# WATER QUALITY M E M O R A N D U M

## Utah Coal Regulatory Program

RE: 2009 3rd Quarter Water Monitoring, Consolidation Coal Company, Hidden Valley Mine, C/015/0007-WQ09-3, Task ID #3383

Flow vs. Time

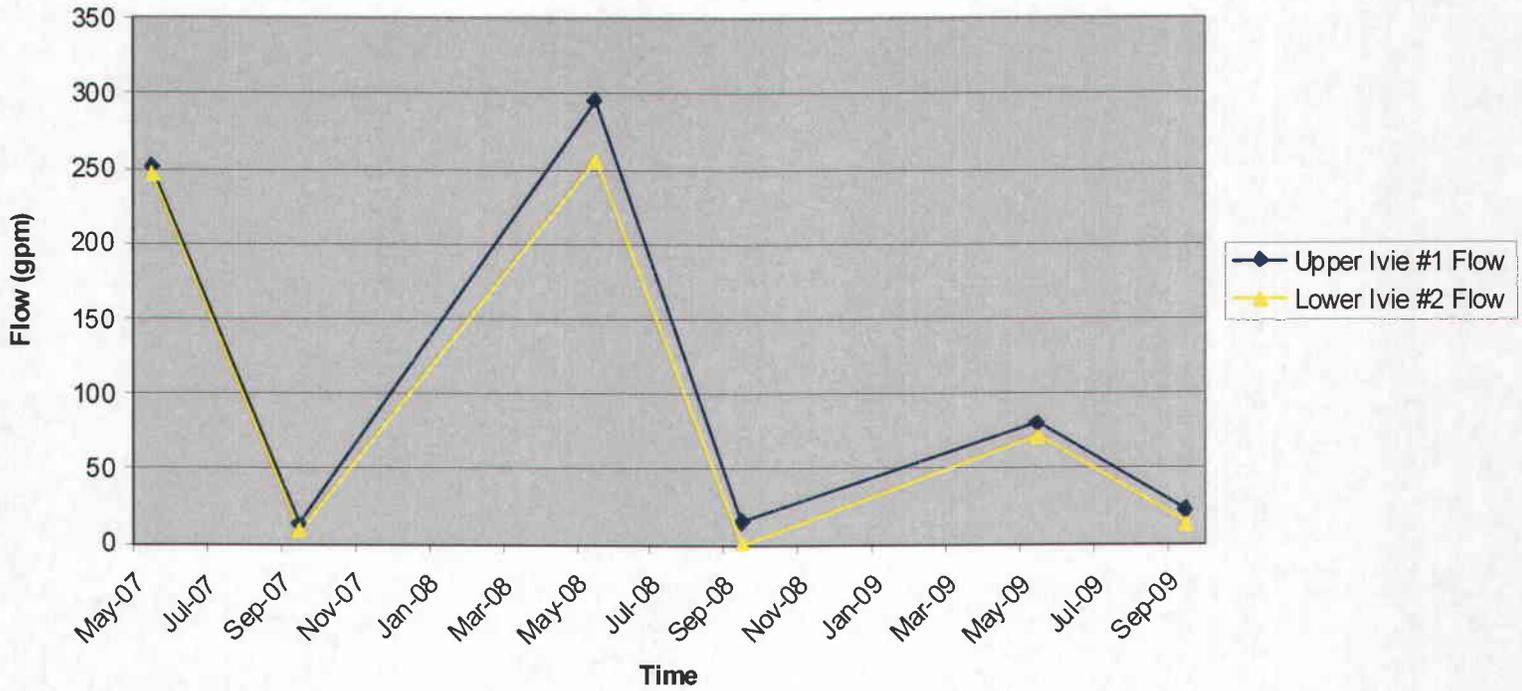
As opposed to the previous quarter, flow values obtained from both sampling sites during the 3<sup>rd</sup> quarter were consistent with previously established seasonal trends (See figures below). 3<sup>rd</sup> quarter flow values for both Upper Ivie #1 and Lower Ivie #2 have been consistently low. Flow values of 22.44 and 13.464 gpm were obtained for Upper Ivie #1 and Lower Ivie #2 respectively. The 2008 3<sup>rd</sup> quarter flow-sampling event produced values of 15 and 0.03 gpm for Upper Ivie #1 and Lower Ivie #2 respectively

Additional investigation/analyses should be performed following subsequent sampling events to identify what factors may be contributing to the decline in spring flow values for the Ivie Creek drainage.

pH vs. Time

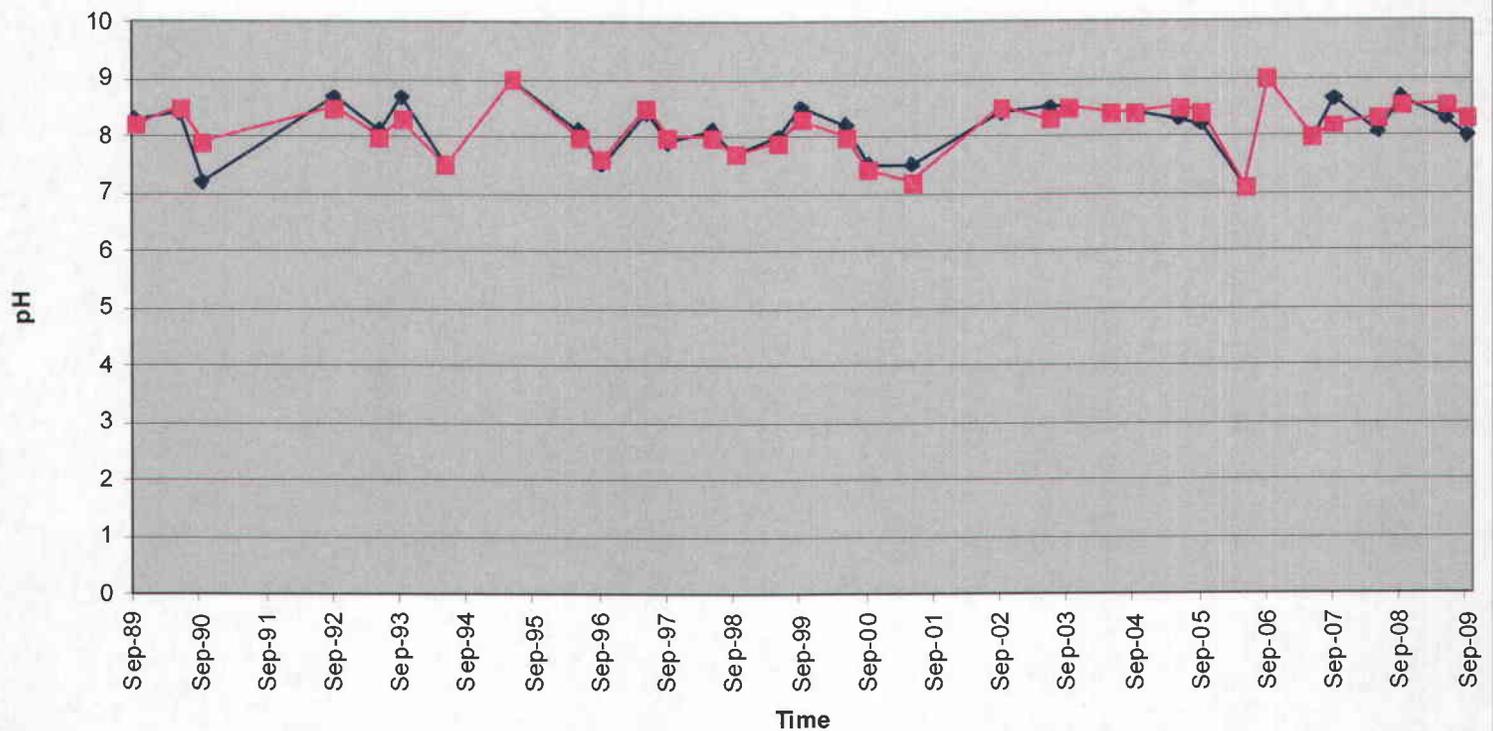
Values obtained for pH and TDS for this quarter follow historic seasonal trends (See Attached Figures).

**TDS vs. Time**

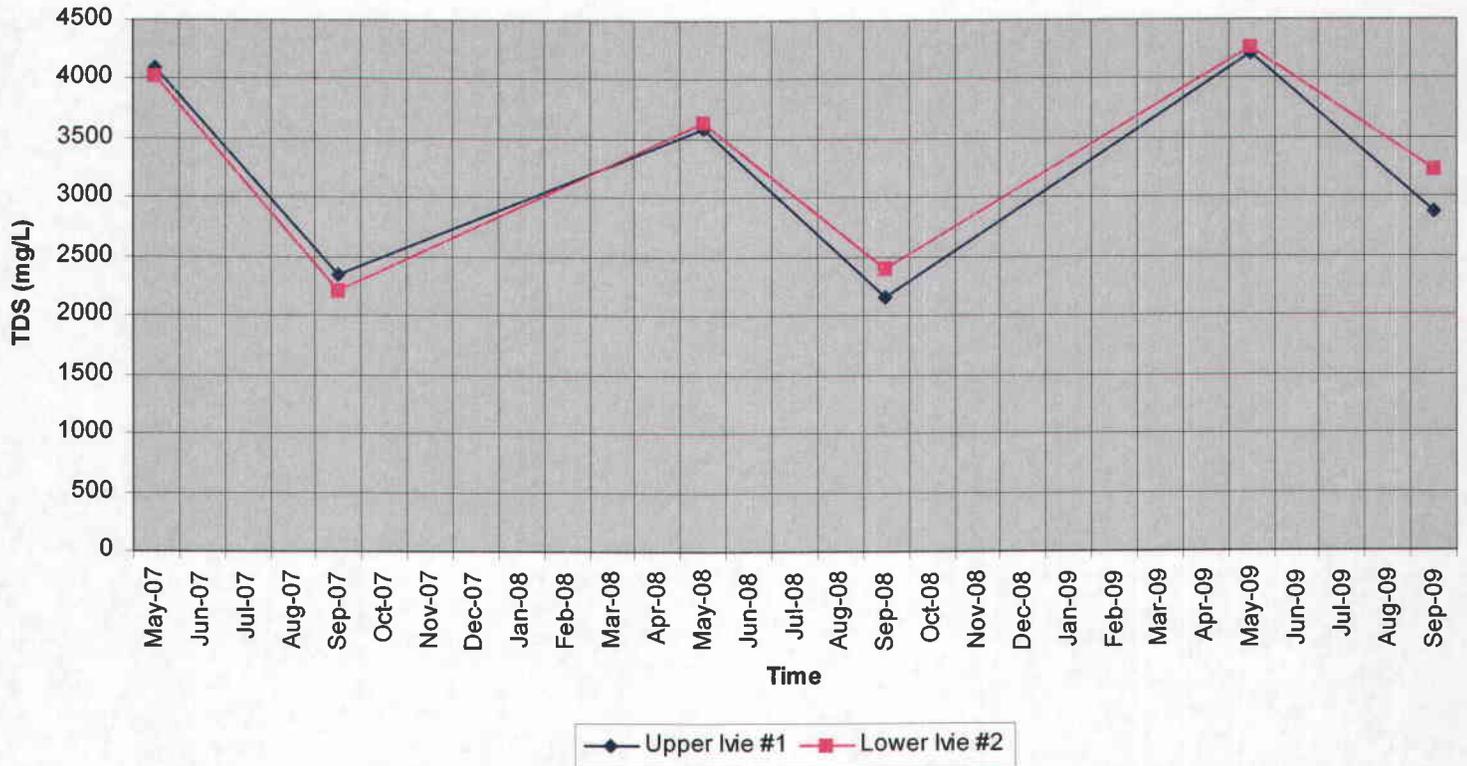
A TDS value of 2,600 mg/L is the site-specific standard as established by UAC R317-2, *Standards for Waters of the State*. The TDS values obtained for both Upper Ivie #1 and Lower Ivie #2 for the 3<sup>rd</sup> quarter were 2,877 and 3,227 mg/L respectively.

Based upon previous sampling data, seasonal TDS trends for the Ivie Creek drainage produce higher values during the 2<sup>nd</sup> quarter (spring/early summer) as opposed to the 3<sup>rd</sup> quarter (late summer/ fall). As a result of snowmelt, irrigation return flow and increased precipitation during the spring/early summer months, it would appear that the ephemeral drainages that contribute flow to Ivie Creek experience a flushing event that produces higher TDS values.

The Ivie Creek drainage has consistently produced TDS levels well above the 2,600-mg/L standard discussed above. However, as the site has been reclaimed, it's unlikely that the elevated TDS levels are a result of coal mining related activity. Recent field inspections by Division staff have documented the site as being in stable condition with no signs of excessive erosion or gullies.
